RBG-47432

SUBJECT: License Amendment Request 2013-18
Revision of Ultimate Heat Sink Design Capacity
River Bend Station – Unit 1
Docket No. 50-458
License No. NPF-47

RBG-47432
Attachment 5

Pending Design Basis Changes
(16 pages)

Figure 9.2-16

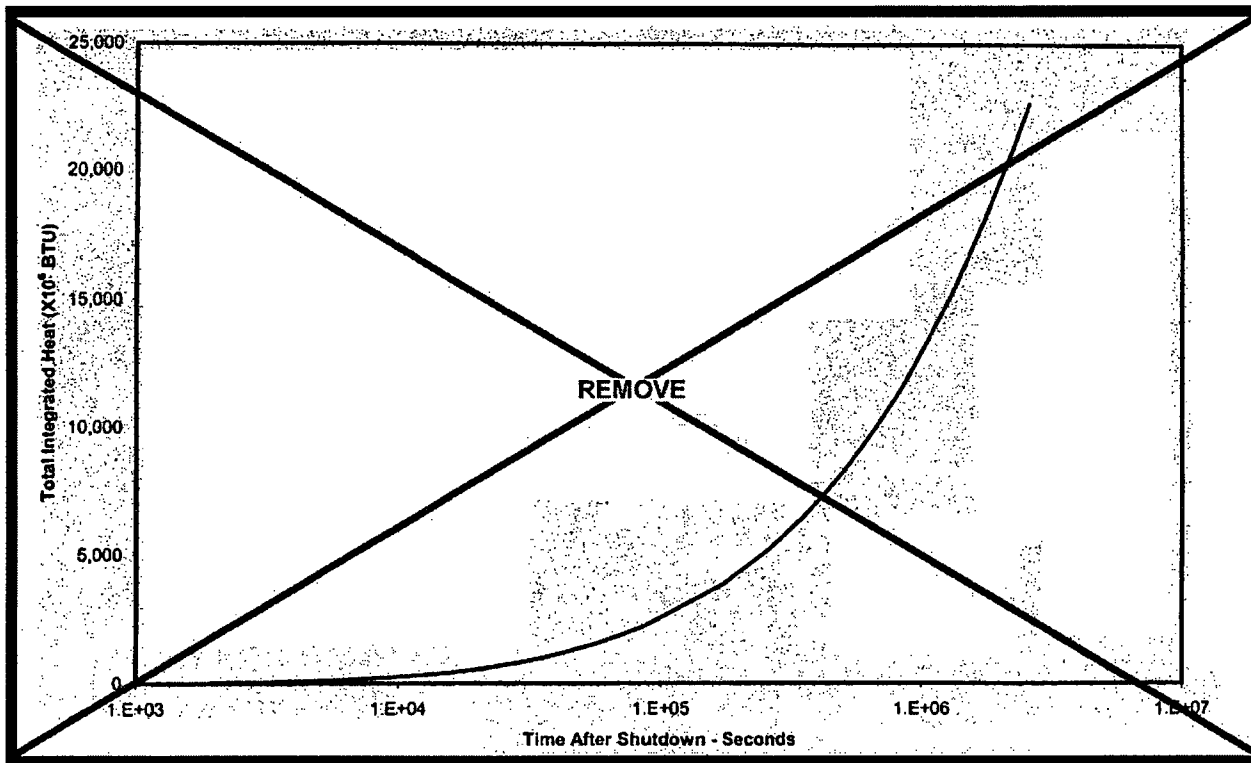
TO BE UPDATED

Note: Information added to Table 9.2-11.

This Figure has
been deleted.
Refer to Table 9.2-5

FIGURE 9.2-17

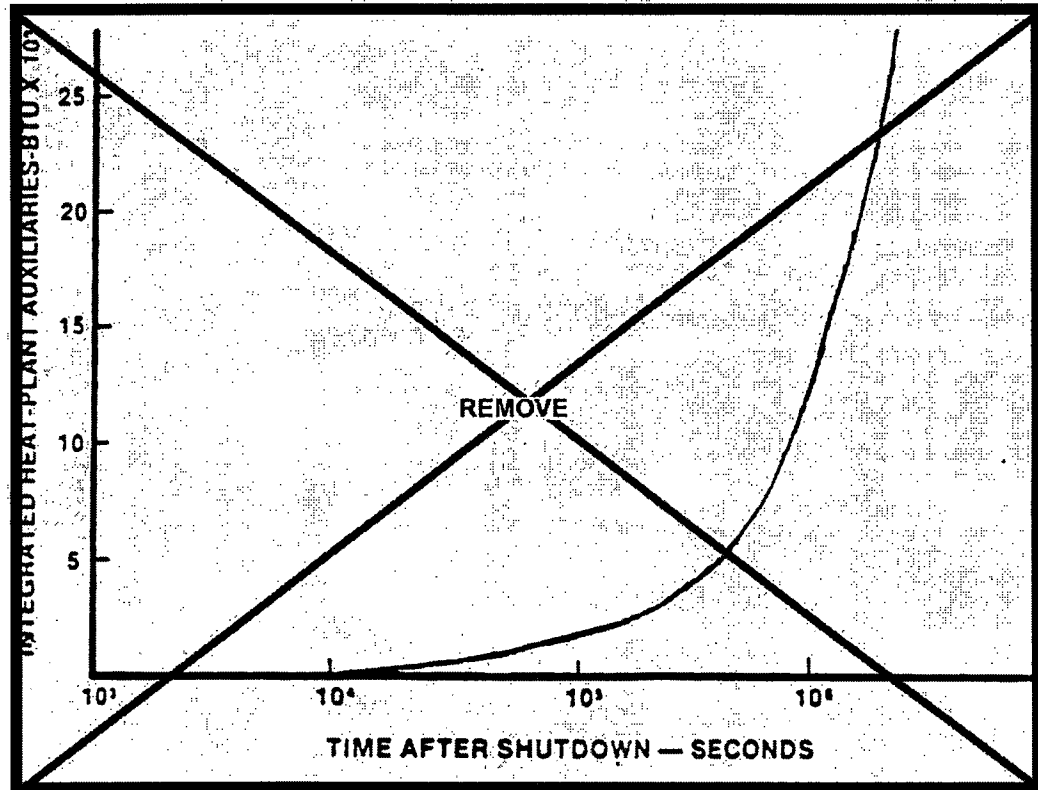
This Figure has been deleted.
Refer to Table 9.2-7
